RE: MP 08_0250 MOD 1 – Modification to Project Application- Hunter Medical Research Institute (Part3AMod) – Finalised Response.

RE: MP 08_0250 MOD 1 – Modification to Project Application- Hunter Medical Research Institute (Part3AMod) – Finalised Response.

Fig 2: Amended Plan of Subdivision Document Ref CCS-1349_DP_2C_P (003).pdf. This extract from the plan of subdivision whilst not appended to the NCC comments, has been included to aid in understanding of the ZHMRI response to the comment.

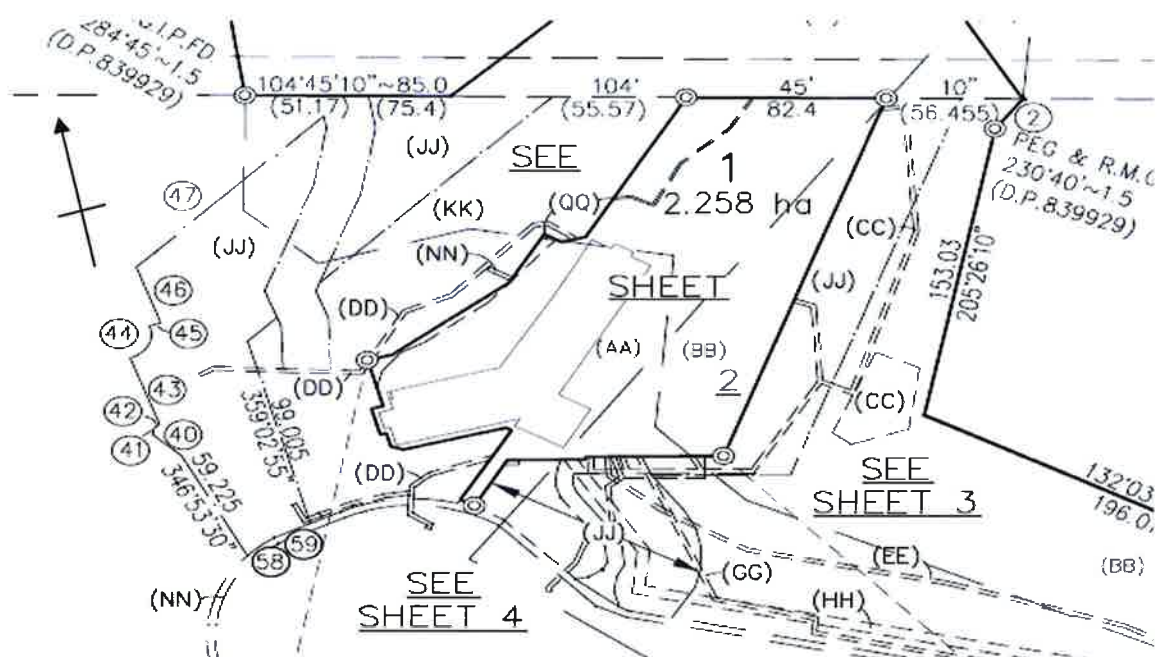
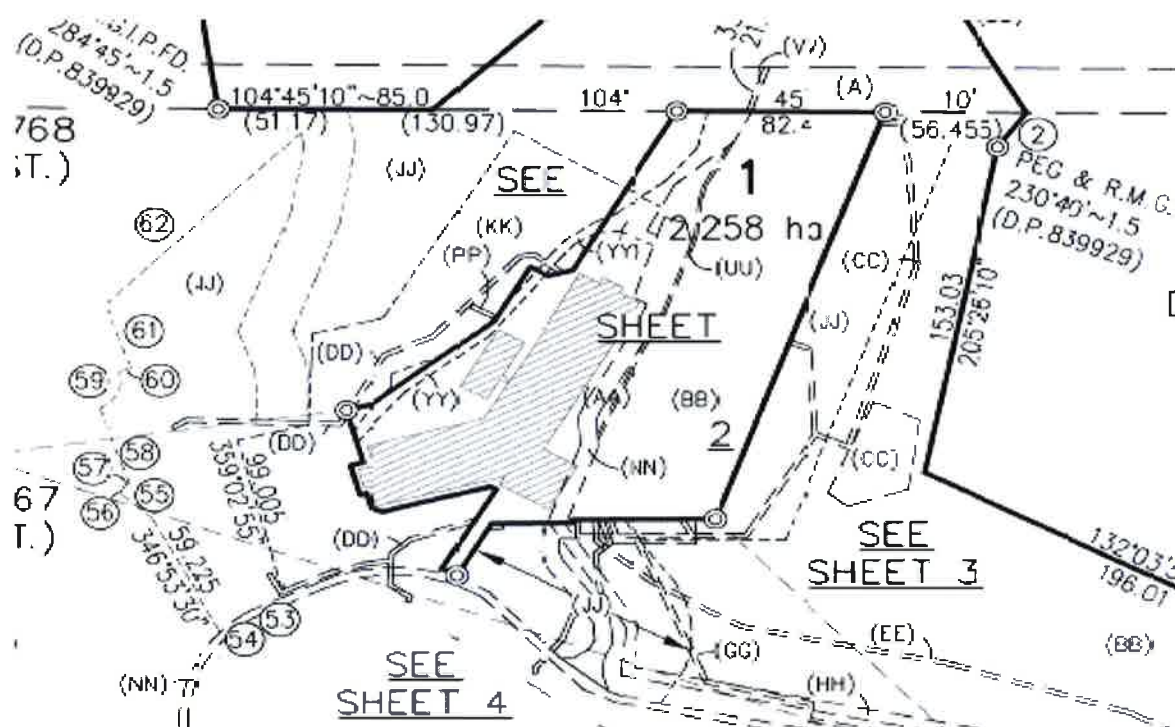
Comment 5 – That part of the land shown burdened by easement (JJ) Outer Protection Zone to the east of proposed Lot 1 should be notated as (KK) Inner Protection Zone is ^(sic) to comply with the Statement of Commitment 7.4 Bushfire – Recommendation 2 (See Appendix B of the Project Approval)

HMRI Response – Cadence Consulting Surveyors have corrected the issues with the definition of the extent of both (JJ) and (KK) generally and specifically corrected the Eastern extent of (KK), restoring it to harmonisation with the Australian Bush Fire Prevention Planners (ABPP) report No. B131943 dated 1/05/2013. We note that this is the latest version of the report. We further note that we have clarified in writing that Graham Swain the author of the report B131943 is satisfied that the representation of the zones in the proposed plans of subdivision Doc Ref CCS-1349_DP_2C_P(003).pdf meet his requirements as set out in that report.

Fig 6. Conditions of Consent Drawing K1002 - key Drawing Access & Movement Pedestrian & Bicycle Movement

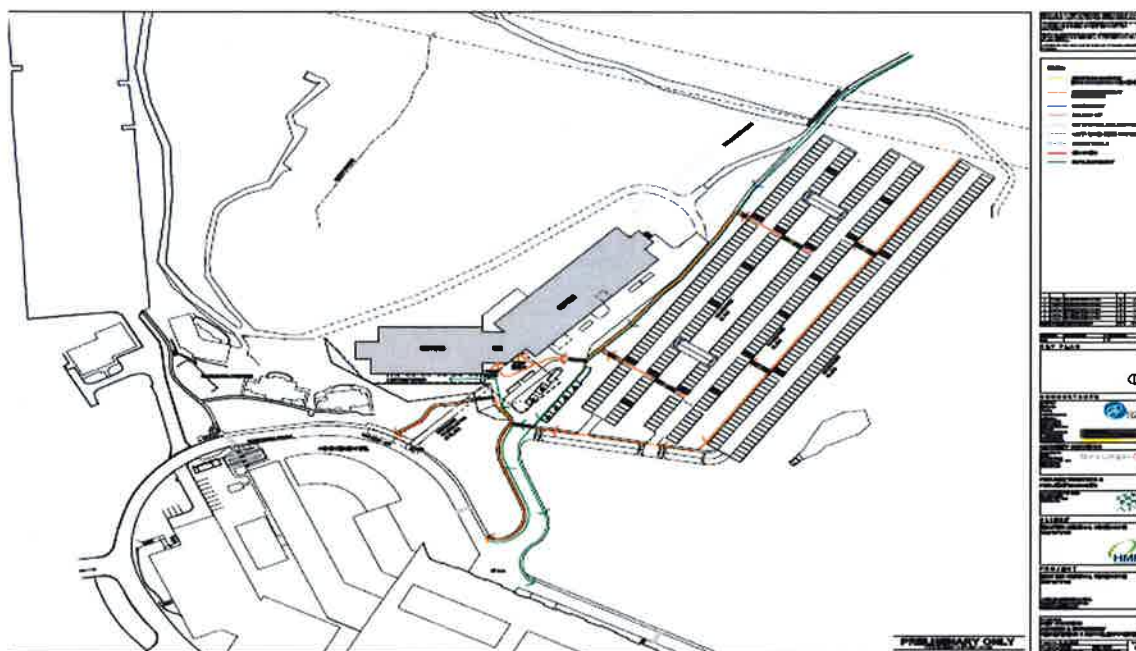
Comment 8 – The shared pathway entering proposed Lot 1 from the bushland to the North appears to be at least 2.5m wide, however proposed Easement (QQ) is noted as a Right of Footway 1m wide and variable. It is also apparent from arial photographs that the shared path provision extends further south than as depicted in the draft DP. The easement should be amended wholly to contain this pathway. Consideration should also be given as to who is to have benefit of this easement as members of the public might use this pathway to access the wider HNEH campus.

HMRI Comment – Sheet 1 to 4 of the Plan of Subdivision identify the following Easements including lots burdened and benefited, and should address the concerns raised by Council :

- **Easement (VV) [Right of cycleway]** links with the end of the Jesmond Cycleway/Walkway and traverses Easement (A) [Easement for electricity transmission lines and access]. This joins seamlessly with;
- **Easement (YY) [right of carriageway 4 wide and variable width]**. This joins seamlessly with;
- **Easement (NN) [Right of carriageway 3.5, 7 wide and variable width]** which forms a contiguous link to the perimeter road network of the John Hunter Hospital

We take the view that the easements created provide a flexible but adequate guarantee of access for cyclists and provides a deemed to satisfy outcome in keeping with :

Schedule 2, Part A – Administrative Condition Clause A2 states that “.. The Proponent shall carry out the project **generally in accordance** with the following plans documentation and recommendations ...” made therein. Specifically, Drawing K1002, Revision 5 Titled “Key Drawing Access & Movement Pedestrian & Bicycle Movement” dated 7/08/2009 and appended here below as Fig. 6, clearly supports a view that it was the intention of the Department when approving the development that there would be a direct linkage between the existing Jesmond shared bike and pedestrian Track and a path of travel through the HMRI site (see the green shaded flow through the drawing).
